RECEIPT DATE: 2/28/17 **ONSITE SEWAGE DISPOSAL SYSTEM** P 5-60557

PROPERTY ADDRESS: 1760 Florence Rd. Mt. Airy, MD 21771

SUBDIVISION: Mocking Bird Forest LOT: 2 TAX ID: 04-371550

**PLOT PLAN**  
SITE PLAN FOR BAT TECHNOLOGY LOT 2  
MOCKINGBIRD FOREST  
PLAT NO. 18776

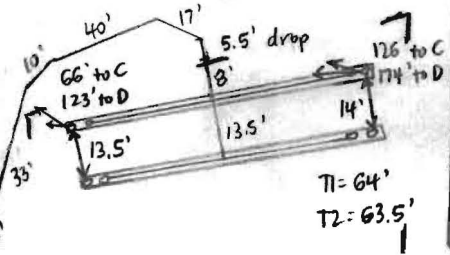
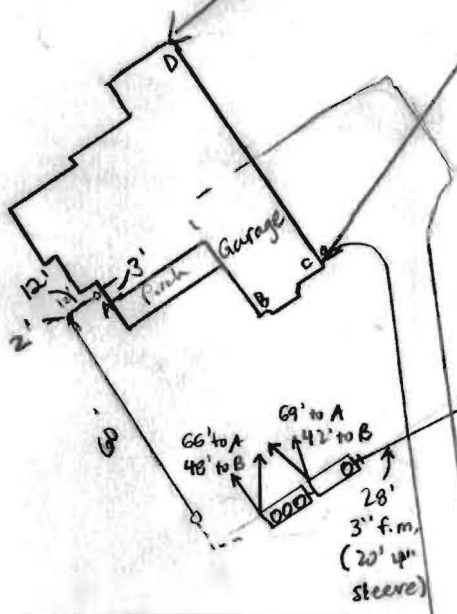
3/21/17 Sams Creek adding stone over lateral pipe.

Finished connecting manifold to laterals while

on site. Need BAT startup and pump

+ alarm test. (SC)

6/9/17 Met Sams Creek on site for pump + alarm.

Lateral head 4.5' at upper trenches, 5' at lower trench.

Alarm sounds. Need 6" riser extension on last 3 manholes + electrical box mounted outside pump tank riser. (SC)

3/2/17 On site for tank layout. Tank stake present but measurements not as shown on BAT plan. Moved tanks ~ 10' uphill from tank to match site on plan. Must stake SDA + trenches before doing layout of trenches. (SC) 3/10/17 Laterals staked. SDA stakes present (stake closest to house knocked over. Checked elevations at ends of trenches starts + ends within 2". May not start trench install until copy of signed plans in hand.

3/3/17 SHC run up to tanks. 3 install "Bells" on sh 40 installed backwards. Need to fix prior to backfill. (Corrective Action) Tank holes dug. P.T. Deep. Explor that tanks no deeper than 4' (P.T. arriving inside not local bowls). 3/5/17 (corrective Action) Bells in 4" SHC replaced w/ couplings (KAW) 3/10/17 Force main run, need 4" sleeve under driveway. (SC) [Picture sent of 20' 4" sleeve under driveway] 3/20/17 Sams creek digging T2, using laser. 3' wide, 0' bottom. (SC) 3/20/17 T2 dug + stone added. 4' inlet. Plan specs don't work with # of surfaces + hole spacing - check with engineer a/b changing hole spacing before proceeding. (SC) 3/21/17 Lateral holes drilled in T2 - spacing correct + no burrs. T1 dug + left open, 0' to bottom + 3' wide. On site while stone added + holes drilled in

6/12/17 Junction box outside pump tank, risers extended 6". Pump runs, alarm sounds. Norweco electric also

ROAD NAME outside tank - Norweco aerator + alarm good. (SC)

LATERAL DETAIL  
NOT TO SCALE

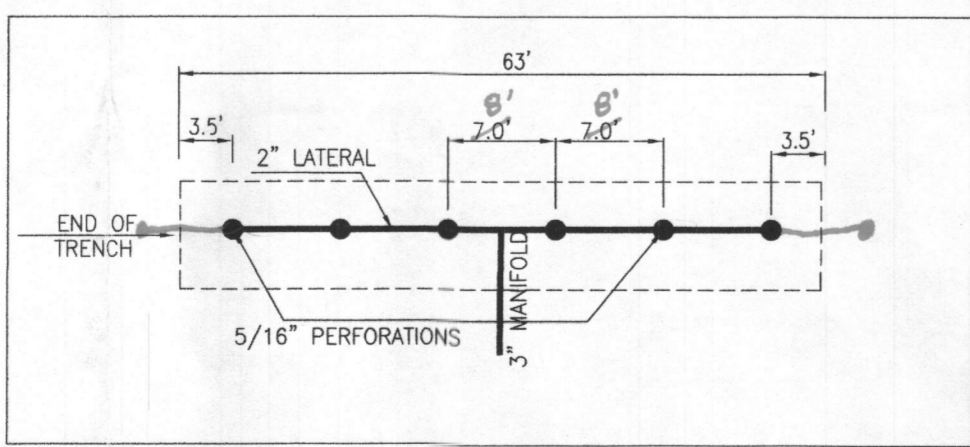
The contractor is doing the septic install for the LPD system at 1760 Florence Road. It seems that the specs should specify 8' hole spacing between orifaces instead of the 7' spacing shown on the plan. We can redline the plan to reflect these changes. Please confirm that changing the spacing to 8' between orifaces will not change any of the other specs on the plan.

Thank you for comments. I concur changing the perforation spacing to 8 feet is fine and this spacing will not impact the pump requirements of the system. Thank you for red lining the plans.
